PLANNING AND INSPECTIONS DEPARTMENT STAFF REPORT

To: Historic Preservation Commission
From: Peter Hughes, Senior Planner
CC: Darryn Burich, Planning and Inspections Director
Kelly Brown, Administrative Specialist
Date: September 2, 2020
Subject: Major COA Request for 190 Linden Road (COA-2020-00113)

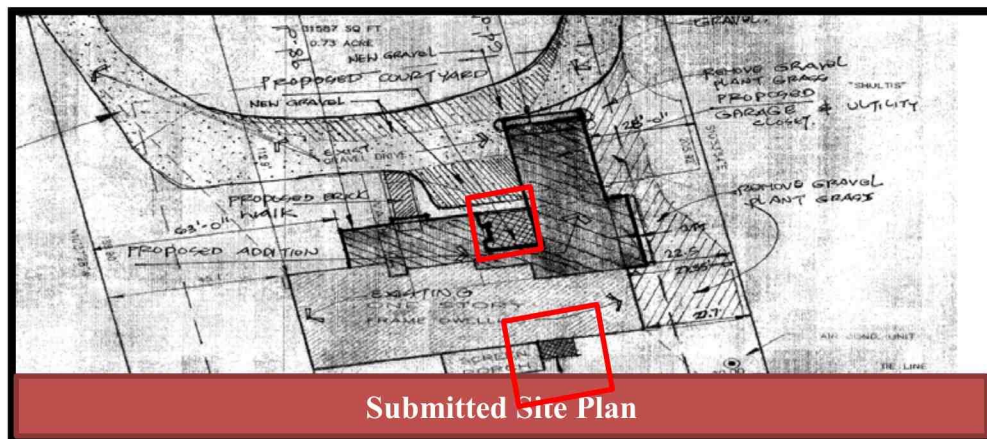
The proposed addition also includes an alteration to the front entrance of the structure. The proposed alteration and redesign of the entrance will result in adding additional architectural detail to the entrance, such as the brick accent wall, which would make the entrance more prominent. In general, the proposed alteration of the front entrance is compatible with the architecture of the structure and would add architectural elements featured on other homes in the Historic District.

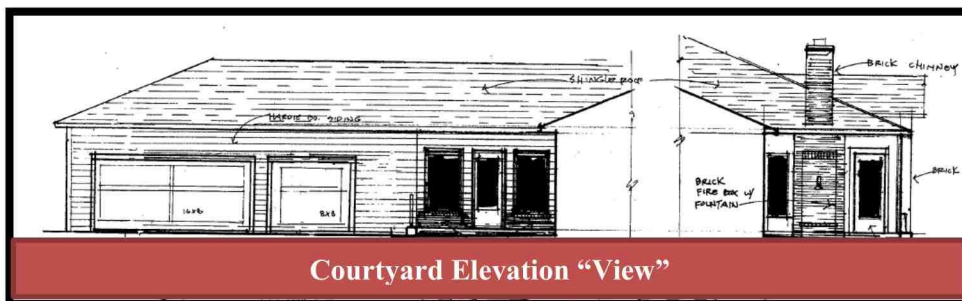
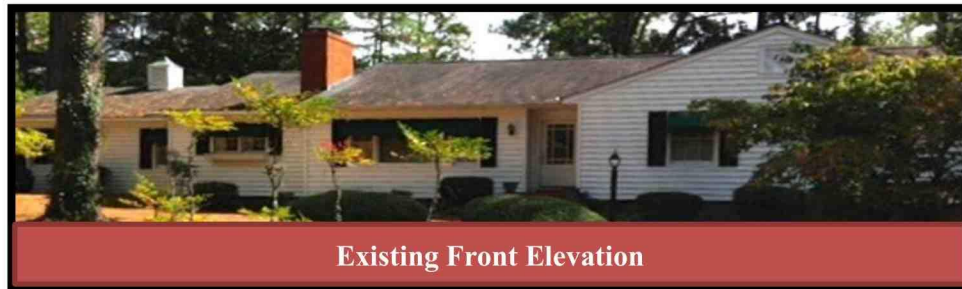
Based on the submitted elevations the proposed addition would be compatible with the architectural character of the structure and would appear to be similar to other structures within the Historic District. The elevations also include introduction of new architectural detail and character to structure, such as a brick accent around the front door and proposed front courtyard, both of which would appear similar to other structures within the proposed Historic District.

The applicant has indicated that the square footage of the home would increase from 2400 to 4200 square feet, which is a 75 percent increase in square footage. The height of the addition and proposed roof configuration appear to match or complement the existing structure. The structure as proposed would appear to be similar in scale to other structures within the Historic District.

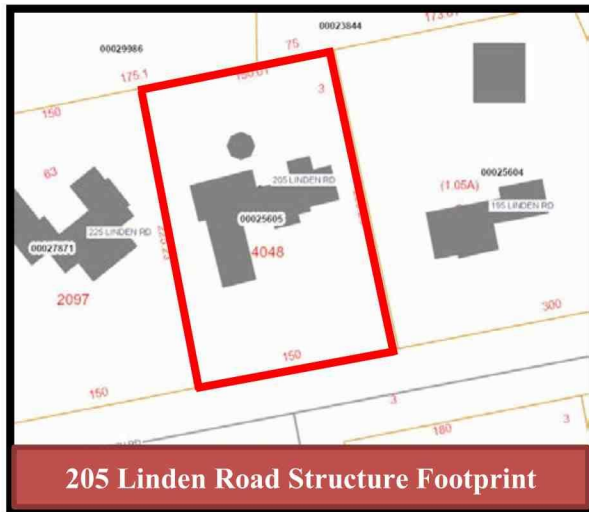
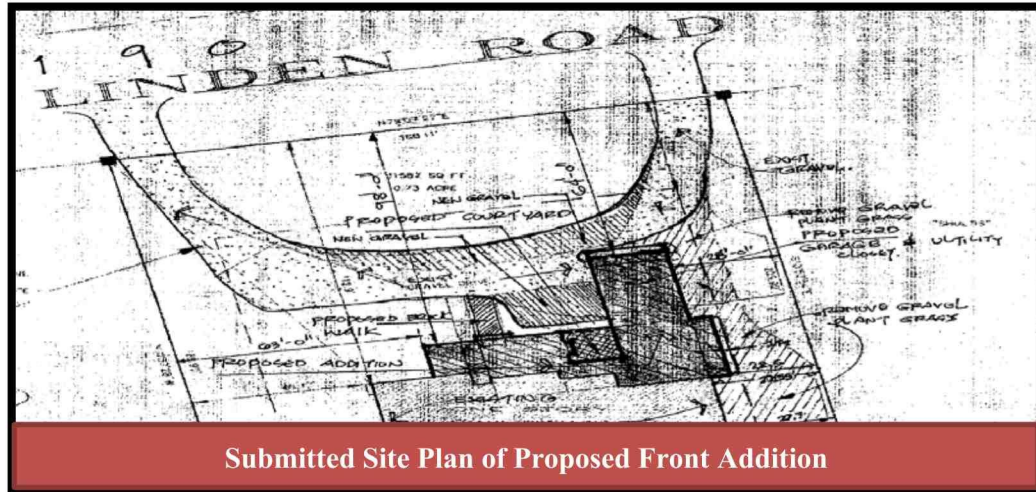
The proposed addition will be a front addition, which is not compliant with the Historic District Guidelines. Based on the size of the addition and the placement of the existing structure, a rear or side yard addition would have been difficult. Front additions or building wings that extend past the principal façade are not uncommon within the Historic District. There are multiple structures throughout the district that have a similar building footprint. Both 175 Linden Road and 205 Linden Road have front additions and are located within 300 feet of the subject property. The Commission has the ability to approve a request that is not consistent with the Guidelines if the request is deemed to be congruous with the Historic District.

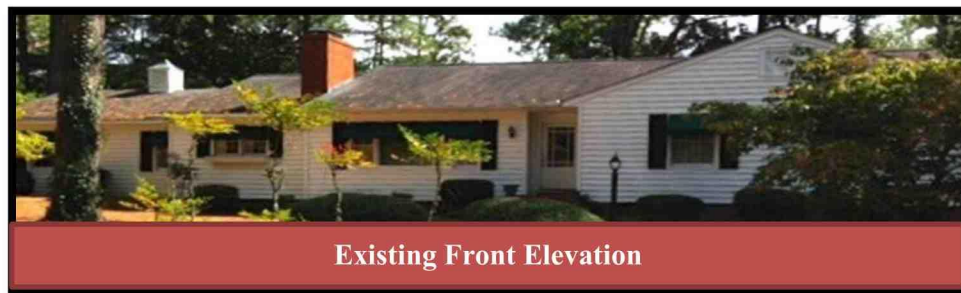
Based on the elevations, it does not appear that the new windows will retain the original size and dimension of the existing windows.

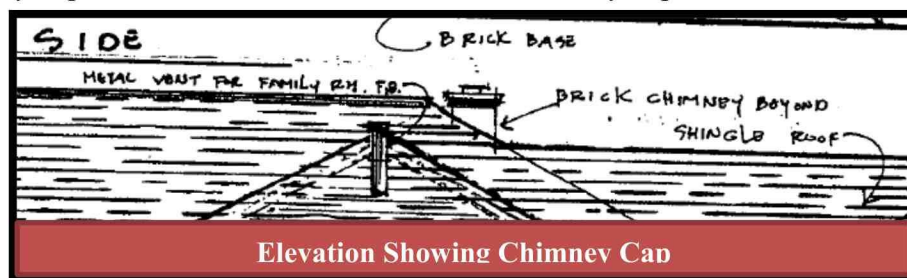
The proposed chimney is brick. The proposed chimney would be compatible to other proposed masonry detail if approved.

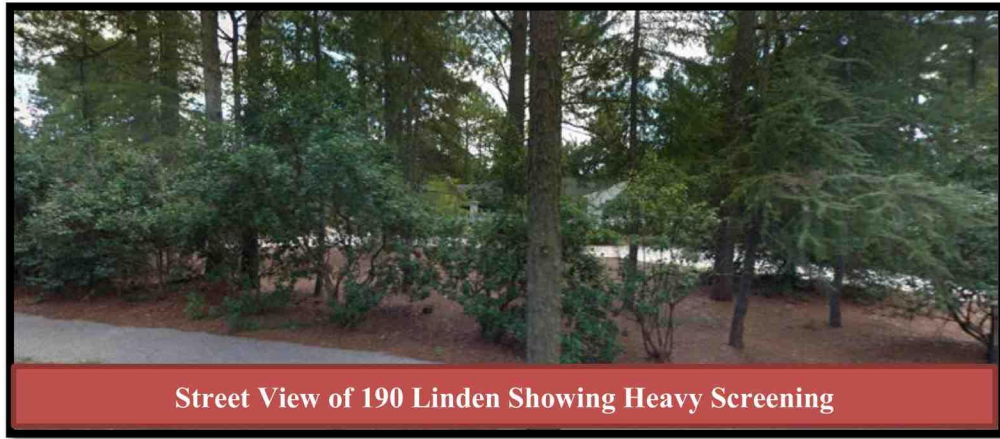
Based on the submitted elevation the foundation of the proposed addition would align with the primary structure.
